UNITED STATES PATENT AND TRADEMARK OFFICE

APPLICATION NO.	FILING DATE	FIRST NAMED INVENTOR	ATTORNEY DOCKET NO.	CONFIRMATION NO.
10/621,404	07/18/2003	Sadaji Katogi	Q76523	2814
21171	7590	05/04/2005	EXAMINER PICKARD, ALISON K	
STAAS & HALSEY LLP SUITE 700 1201 NEW YORK AVENUE, N.W. WASHINGTON, DC 20005			ART UNIT 3676	PAPER NUMBER

Office Action Summary

Fig. 12
PRIOR ART

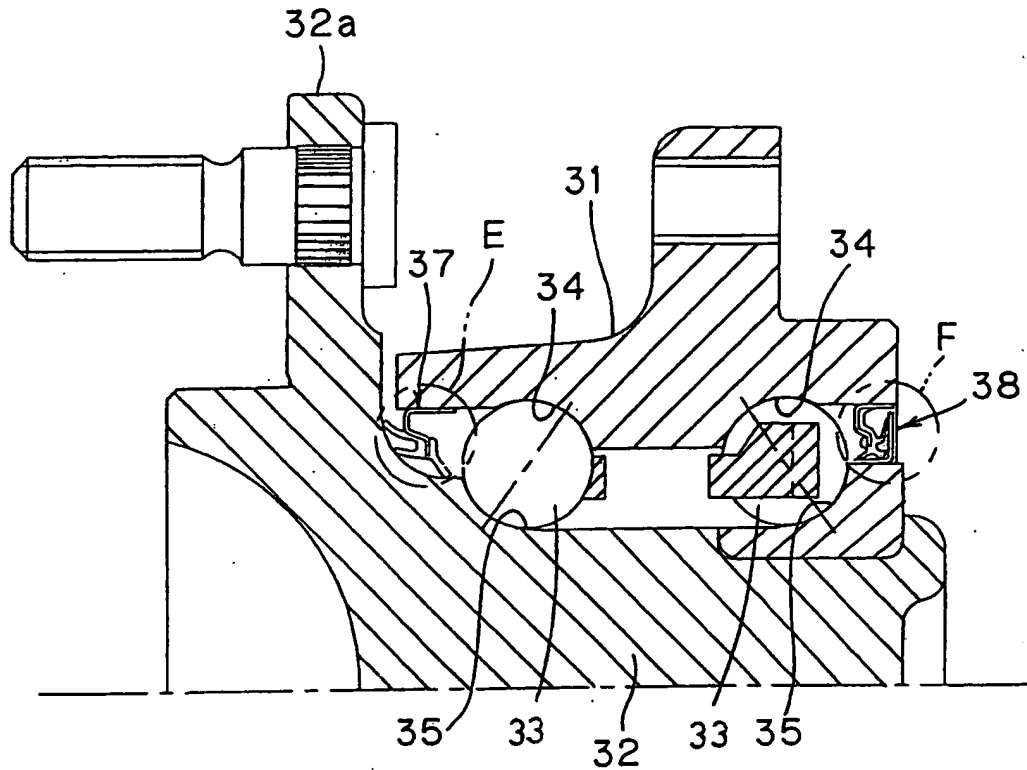
4. Claims 1-8, and 10 are rejected under 35 U.S.C. 103(a) as being unpatentable over Applicants' Admitted Prior Art (APA) (spec. pages 1-3 and Figures 12, 13A, and 13B) in view of Otto.

Fig. 13A
PRIOR ART

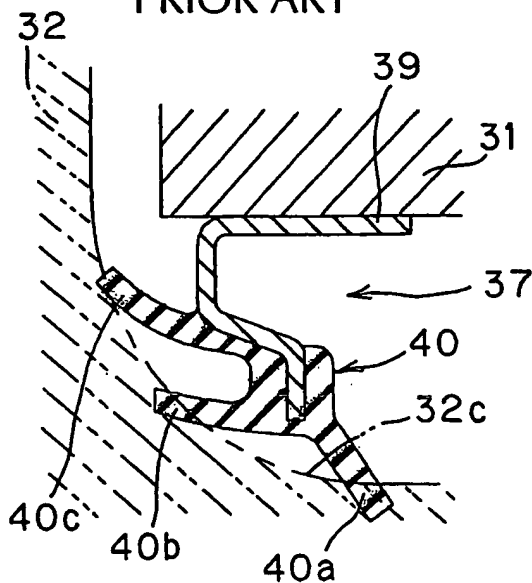
Applicants disclose a known assembly comprising an inner member, outer member, rolling elements, and at least one sealing member. The sealing member comprises plural lips extending toward either an L-shaped contact member 45 (Fig. 13B) or toward an inner member having a flange 32 (Fig. 13A). Applicants do not disclose that an innermost lip is a non-contact sealing lip. Otto teaches an assembly comprising an inner member, outer member, rolling elements, and at least one sealing member. The sealing member comprises plural lips. Otto teaches forming an axially innermost lip as a non-contacting lip. Otto teaches leaving a gap between a grooved free endface of the lip to pump lubricant back toward the bearing. Therefore, it would have been obvious for one of ordinary skill in the art at the time the invention was made to modify the axially innermost lip of admitted prior art with the teachings of Otto to pump or impel the lubricant back toward the bearing and improve the seal assembly.
